**RE: Potential Change Order 0093  
Collin County Justice Center - 3090**

Hunt Construction Group (Hunt) respectfully requests your review and approval of the attached Potential Change Order (PCO) number **0093** as titled: **Louwer Flashing & Lintels per RFI 326**. This change is required to provide masonry support lintels & flashing at louwer types 'EE' and 'LL'. Cost to complete the work is as follows:

## Request for Information 326

**COLLIN COUNTY JUSTICE CENTER**  
 LOUVER HEAD SECTION @ STONE VENEER  
 REFER SECTION 5/A6.54 3 1/2" L O"  
 APPLIES AT LOUVER TYPES EE & LL  
 PGAL PROJECT NO. 590.02038.04  
 RFI 326 SKETCH 060711-A1

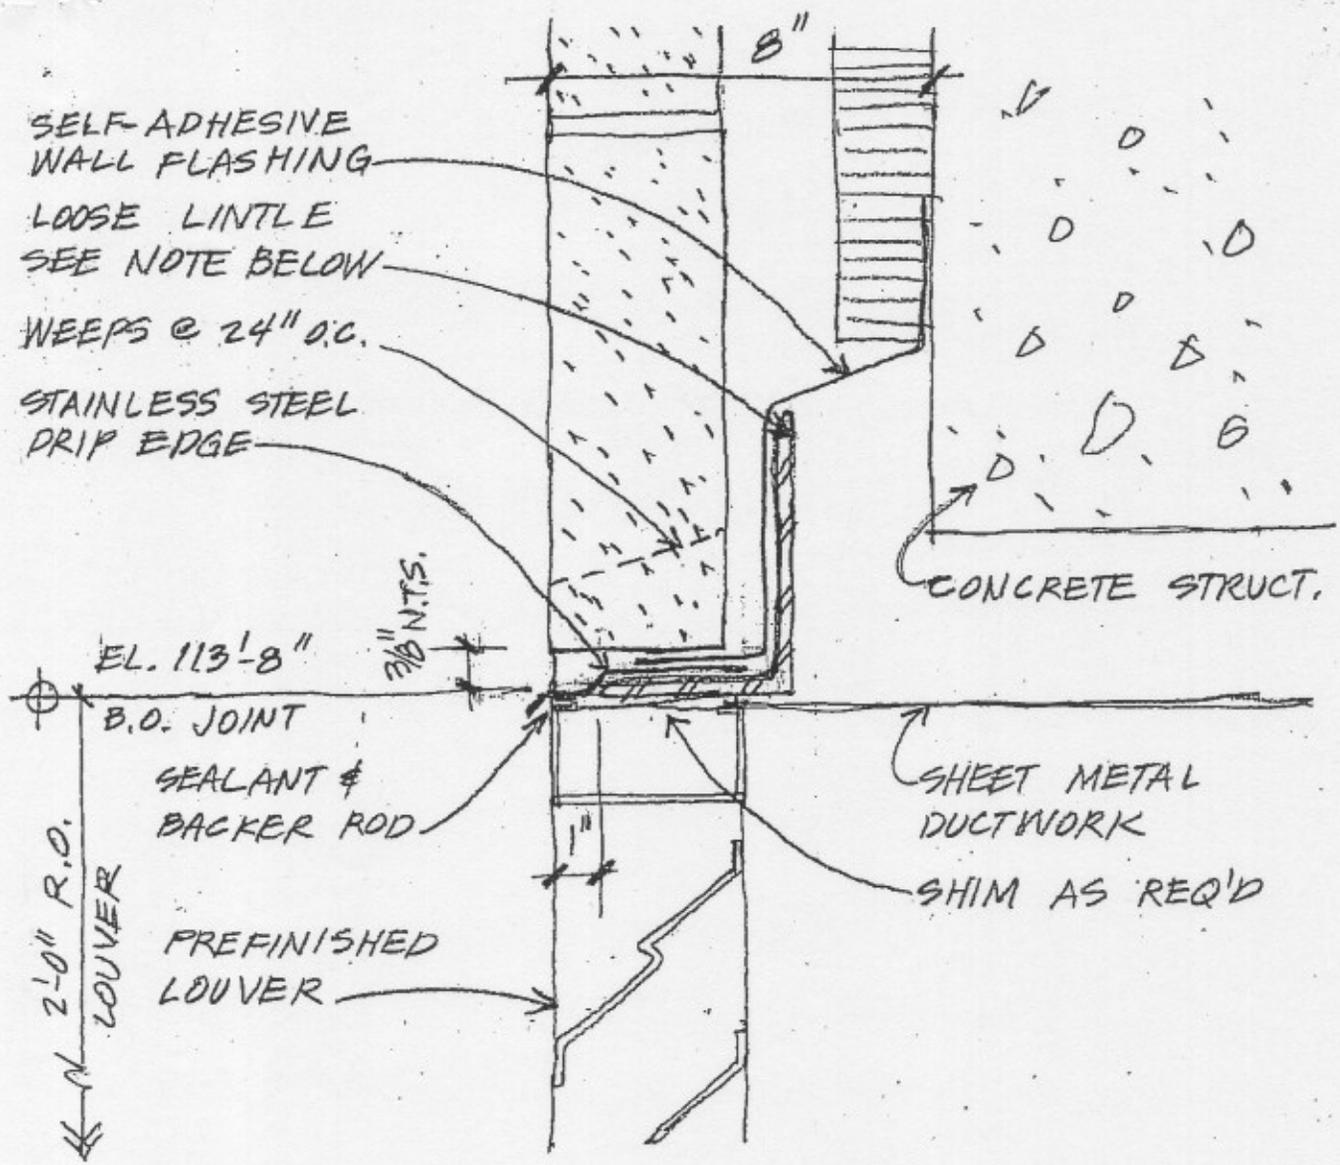
Ref. A6.54:

Architectural aluminum louvers at exterior facade do not indicate any flashing to be installed above them. Additionally, section 5/A6.54 suggests that the cast stone should rest directly on the louver.

1. Hunt suggest consideration be given to configuring head condition similar to section 4/A6.77. If acceptable, please provide lintel size, anchorage requirements, and flashing termination details.

1. Provide a loose galvanized steel lintel and flashing per attached sketch 060711-A1. This detail will apply to louvers EE (2'-0" x 5'-0") and LL (2'-0" x 10'-0"). See plan on A2.01.

LOOSE LINTLE SHALL BE GALV. L 6X4X 5/16 LLV. w/ 8" MINIMUM BEARING AT EACH END. HOLD LINTLE BACK 1" FROM FACE OF STONE & CONCEAL AT BEARING ENDS w/ 3/8" MORTAR JOINT. STONE UNITS DO NOT NEED TO BE NOTCHED FOR LINTLE.
